T.I. no.: 2021-29 Updated: -	Topic: SC Club Software Version 2.2.3
---	--

Date: 28.10.2021	Priority	Need for action
Affected machines: SC Club	High	As soon as possible
From serial number: -	X Medium	X On next visit to the machine
As of date: Immediately	Low	FYI only

SOFTWARE RELEASE NOTE

Additional coffee resp. espresso expert settings

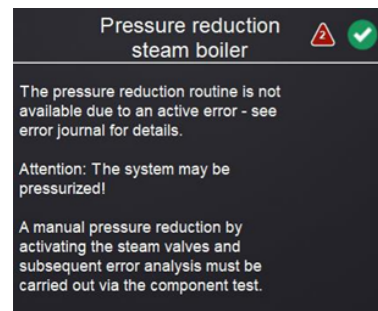
With the new software version, further setting possibilities have been implemented in the expert settings. It is now possible to adjust the pre-infusion quantity and to relieve the brewer prior to wet pressing.

Pre-infusion quantity

- Auto: Corresponds to the previous setting. If pre-infusion is activated, the pre-infusion quantity is automatically dosed according to the set ground coffee quantity
 - 0 – 30 ml: If pre-infusion is activated, the set pre-infusion quantity is dosed
- Recommended setting „Auto“ in order to get a more consistent brewing

Relieve brewer

- 0 mm: the brewing chamber is not opened prior to wet pressing
 - 1 – 5: the brewing chamber is opened prior to wet pressing according to the setting.
- Maintain recommended setting „Keep factory settings“ in order to get a more consistent brewing

In order to reach all settings, a scroll bar was implemented to move the display.
